TENNESSEE VALLEY AUTHORITY

Enclosed for your review are requests for relief from ASME Section XI preservice and inservice inspection requirements for Watts Bar Nuclear Plant. It is TVA's intent to revise the Preservice and Inservice Inspection Program for Watts Bar to reflect these exceptions. We request that any NRC comments on the enclosed material be forwarded to us by July 1, 1980.

REQUEST FOR RELIEF ISI-2

TENNESSEE VALLEY AUTHORITY DEPARTMENT OF POWER PRODUCTION			
WRNP			
STEAM GENERATOR WELD MAP UNIT I			
SCALE	APPROVED	DATE	4-26-79
DATE	BY	CHKD	
ISSUED			CH-M-2660-B

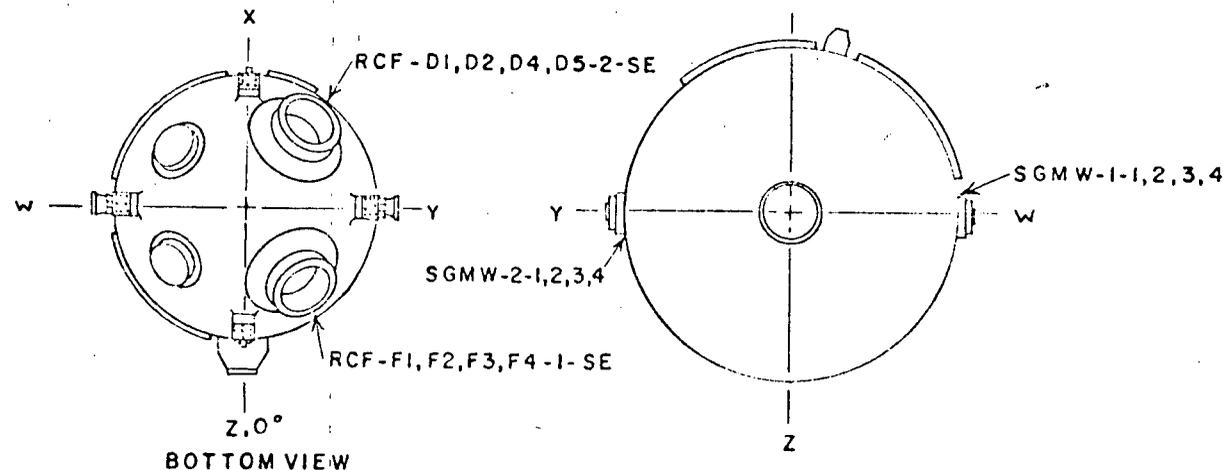
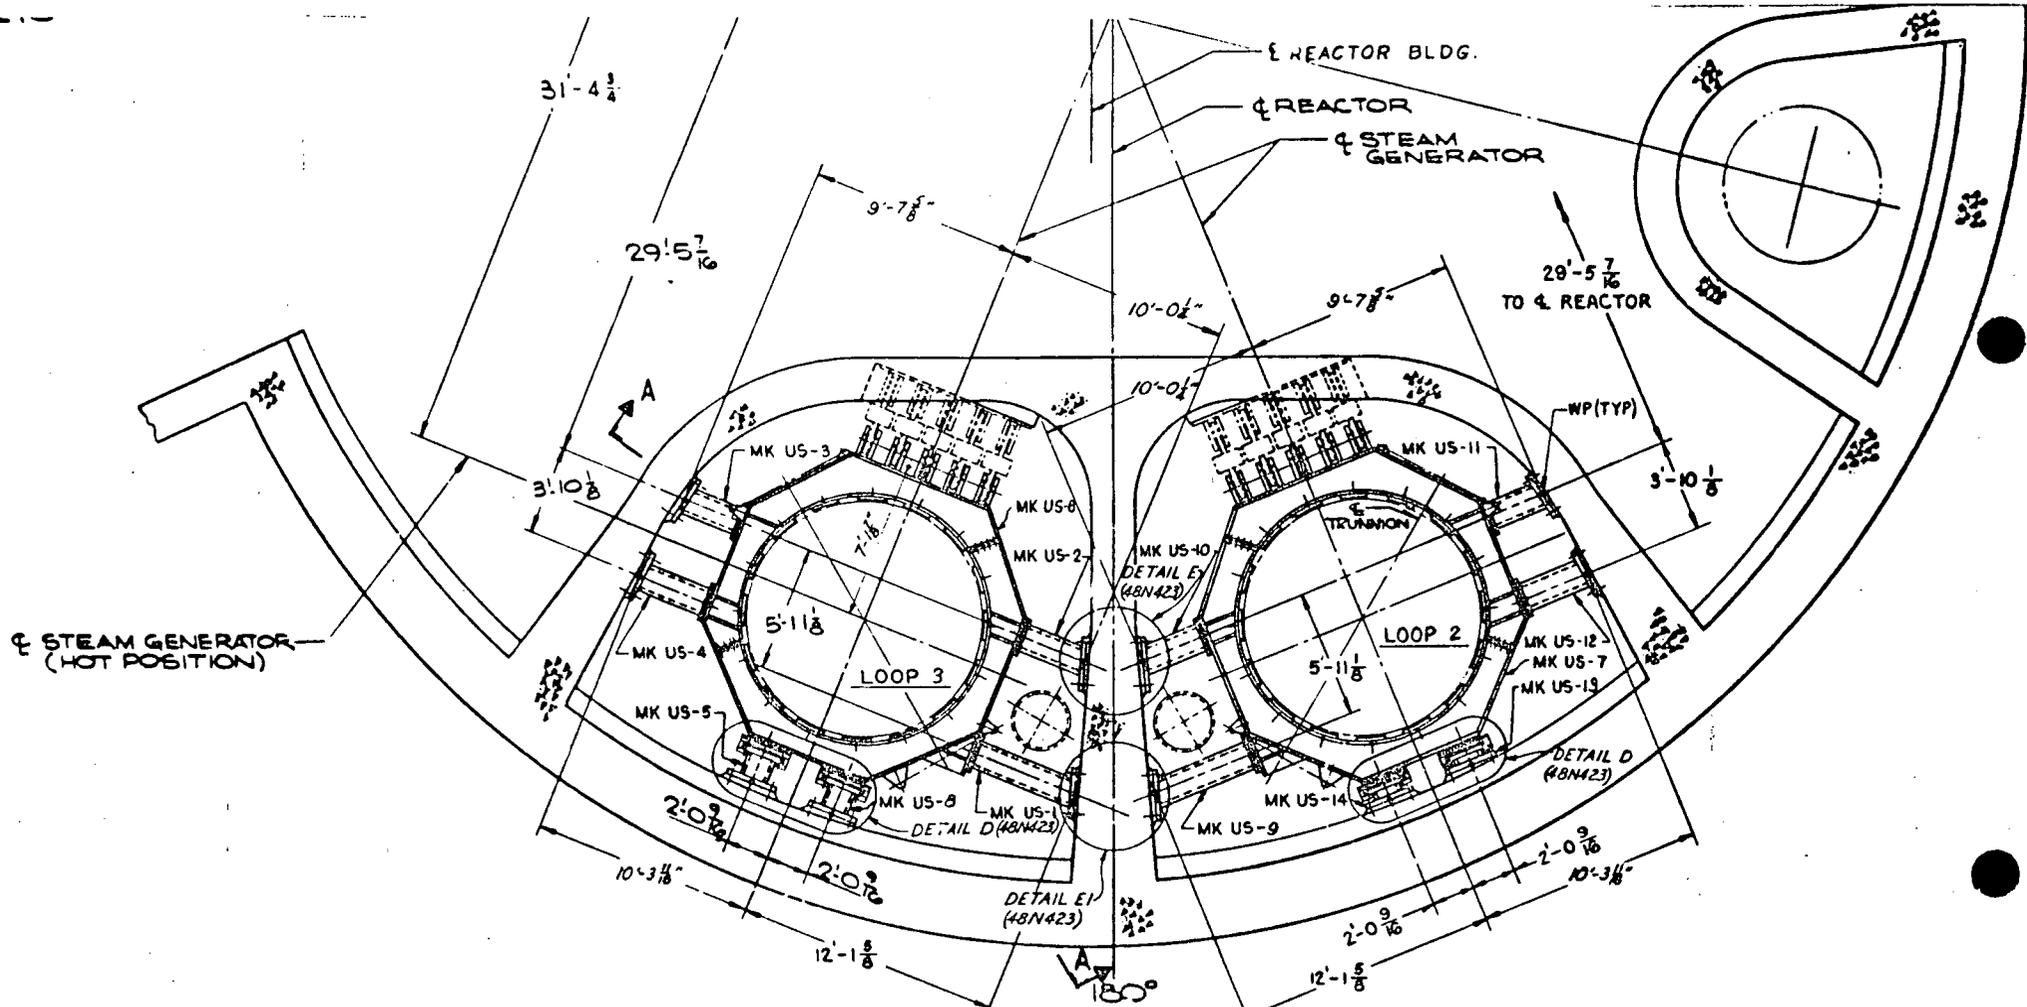
Basis for Relief: One circumferential shell weld on each generator is inaccessible due to the upper steam generator support brackets (weld numbers SG-4B-5-1, SG-4B-5-2, SG-4B-5-3, and SG-4B-5-4). See attached drawings. One weld on one generator will be examined on a "best effort" basis for the baseline inspection and during the four inservice inspection intervals in accordance with IWC-2411.

Alternate Inspection: None.

REACTOR VESSEL STEAM WELDS
WATTS BAR NUCLEAR PLANT

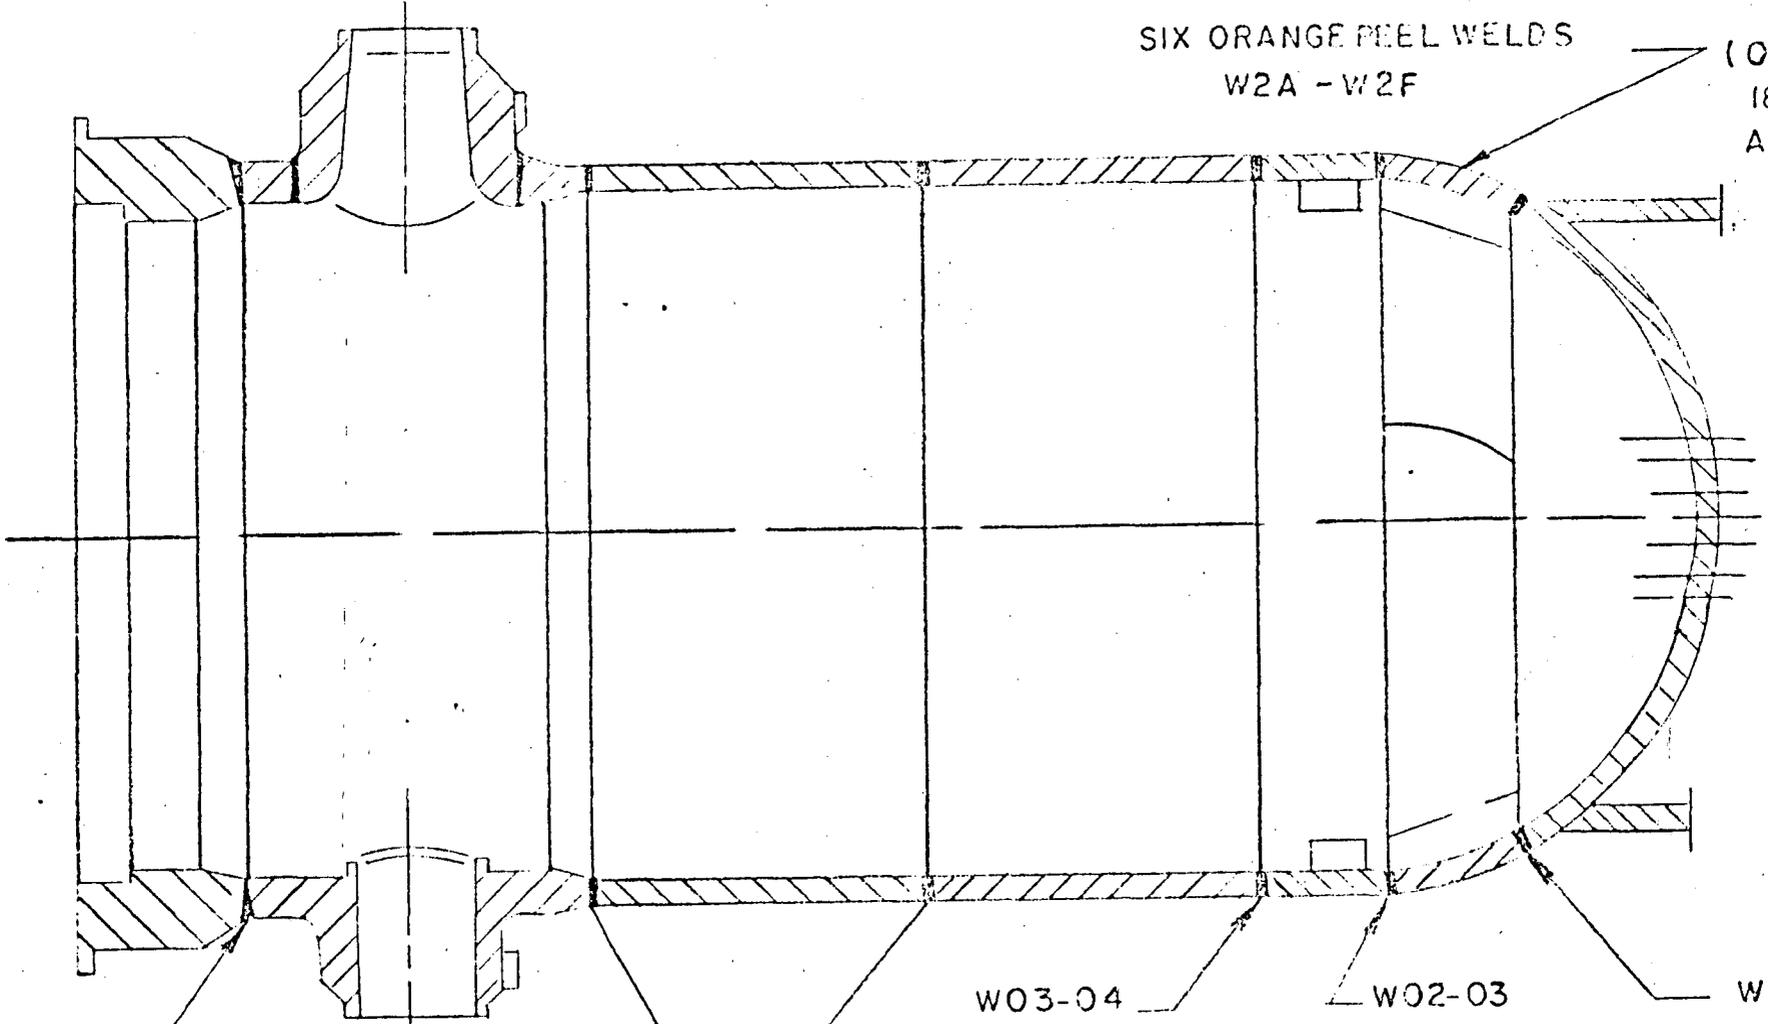
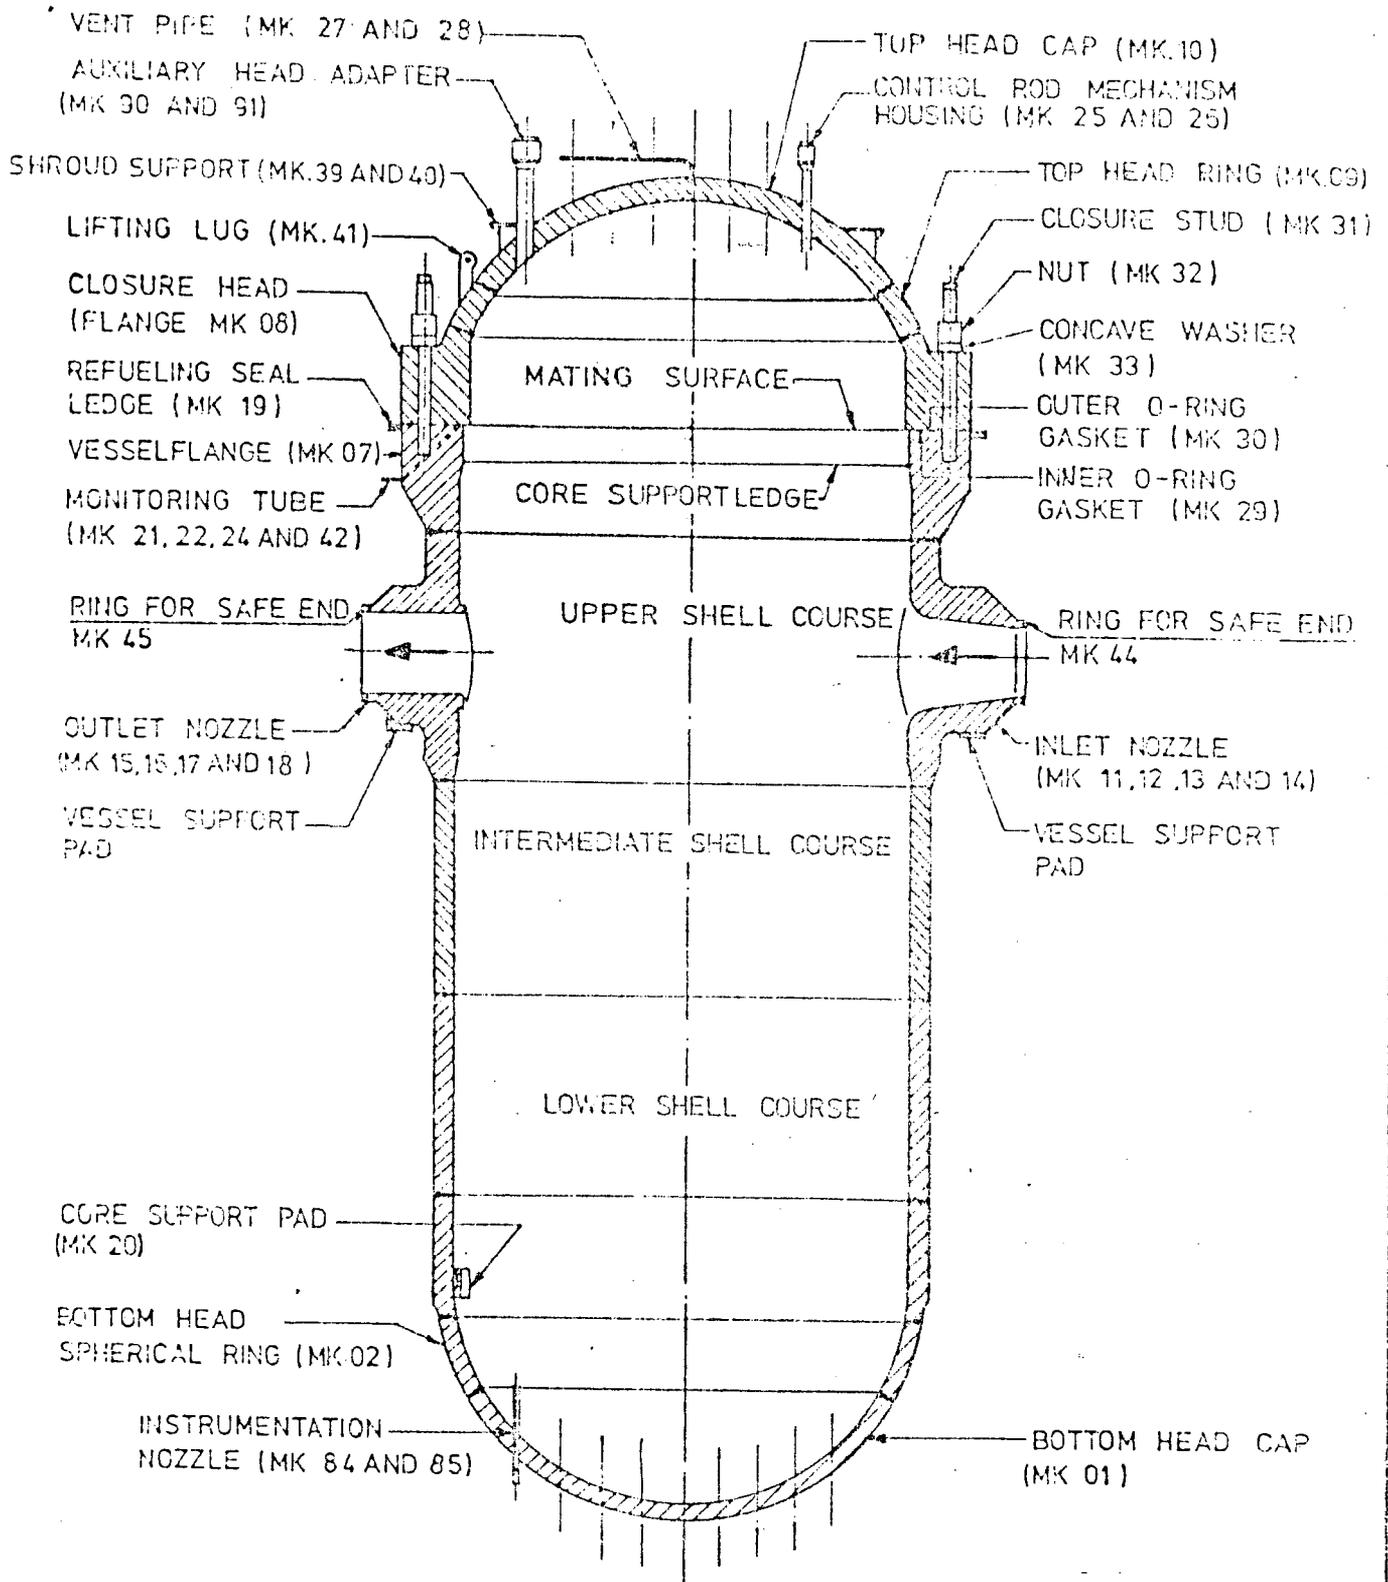
Basis for Relief: TVA will employ automated remote inspection devices to examine most of the reactor vessel welds. These examinations will be conducted from the vessel inside diameter. However, the lower head weld on each reactor pressure vessel is partially inaccessible for examination from the vessel inside diameter due to instrumentation tubes which penetrate the lower head (weld no. W01-02 - see attached drawings). Portions of the weld can be examined from one side (as permitted by I-5121 of Section XI) and will include 100 percent of the examination volume in accordance with IWB-3511.1 of Section XI. These portions of the weld will be re-examined during the inservice intervals in accordance with examination category B-B of Table IWB-2500.

Alternate Inspection: A 100 percent baseline examination of the weld will be conducted from the vessel outside diameter. This will be accomplished by performance of a manual ultrasonic examination. A remote ultrasonic examination will be conducted from the vessel inside diameter on all accessible areas of the weld.
